SUBJECT: Grand Gulf Nuclear Station
Unit 1
Docket No. 50-416
License No. NPF-29
Additional Information on
the 10 Year Inservice
Inspection Program
AECM-85/0349

MP&L'S RESPONSE TO
NRC LETTER OF AUGUST 22, 1985

FIGURE 4

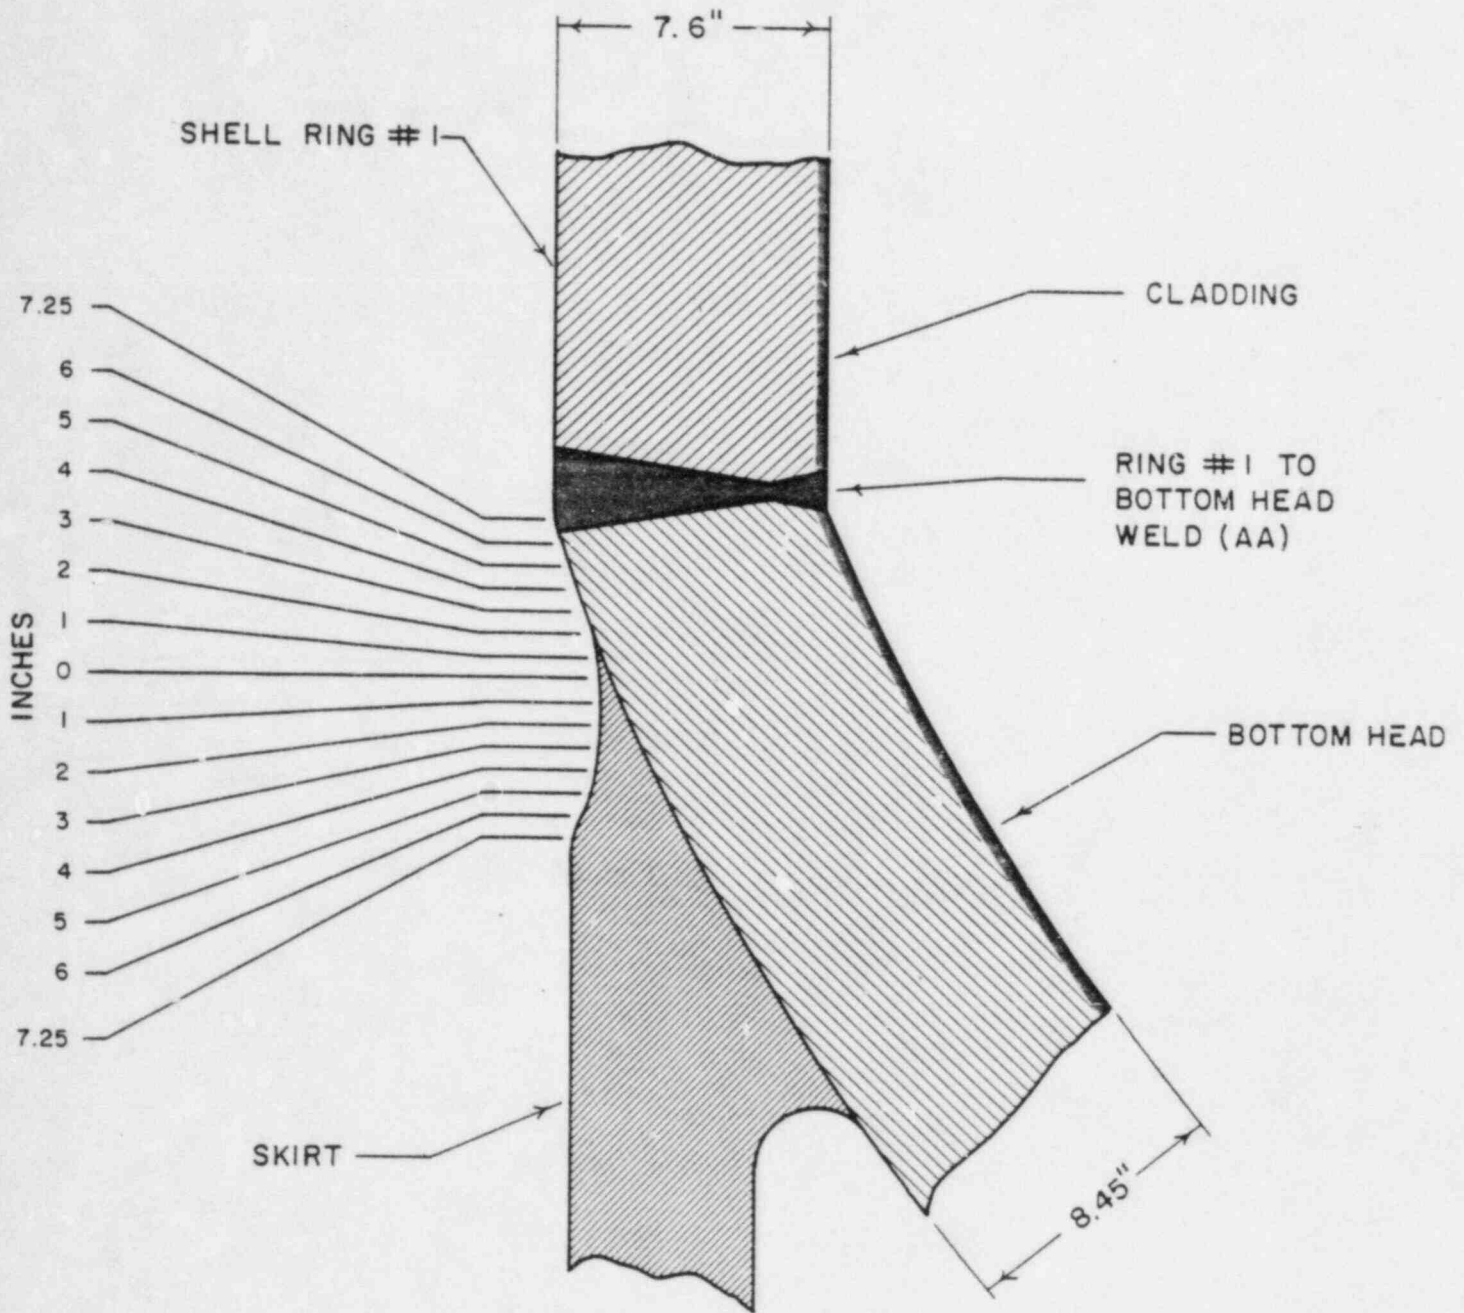
Relief from volumetric examination of the lower one-half of the reactor pressure vessel lower head-to-shell weld (AA) is requested. The principal reason cited for requesting relief is the unavailability of automated equipment to operate on the curved surface of the lower head. Please provide a dimensioned cross-sectional drawing of the lower head-to-shell weld that clearly shows changes in vessel wall thickness and vessel head curvature in the region adjacent to the weld.

A dimensioned cross-sectional drawing of the lower head-to-shell weld including wall thickness and curvature is attached (see Figure 4).
